AGENDA
PLANNING COMMISSION
116 WEST NEEDLES
BIXBY, OKLAHOMA
January 21, 2013 **6:00 PM**

MINUTES
PLANNING COMMISSION
116 WEST NEEDLES
BIXBY, OKLAHOMA
December 17, 2012 **6:00 PM**

To: Bixby Planning Commission
From: Erik Enyart, AICP, City Planner
Date: Friday, November 30, 2012
RE: Report and Recommendations (Revised 12/17/2012 to reflect the revised plans and information received 12/14/2012) for:
BSP 2012-02 – “Andy’s Frozen Custard” – Lewis Engineering, P.L.L.C.

PARKING SPACE DETAIL

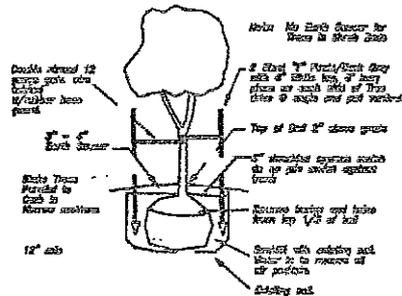
The Applicant has provided Parking Space Detail showing the regular and van-accessible handicapped-accessible parking spaces and access aisle with dimensions as required. While the van-accessible space does, the regular accessible space does not indicate compliance with the 4" "hairpin" striping standards Zoning Code Section 11-10-4.C Figure 3. During the design of these features, the Applicant should confirm with the Building Inspector that the parking and the entire site complies with applicable ADA requirements, including accessible parking spaces and access aisles, appropriate signage reserving the spaces, etc.

- ~~6. Please label the angle of the parking spaces along the west property line.~~
7. For the regular handicapped-accessible parking space, please add to the Parking Space Detail the 4" "hairpin" striping per Zoning Code Section 11-10-4.C Figure 3.
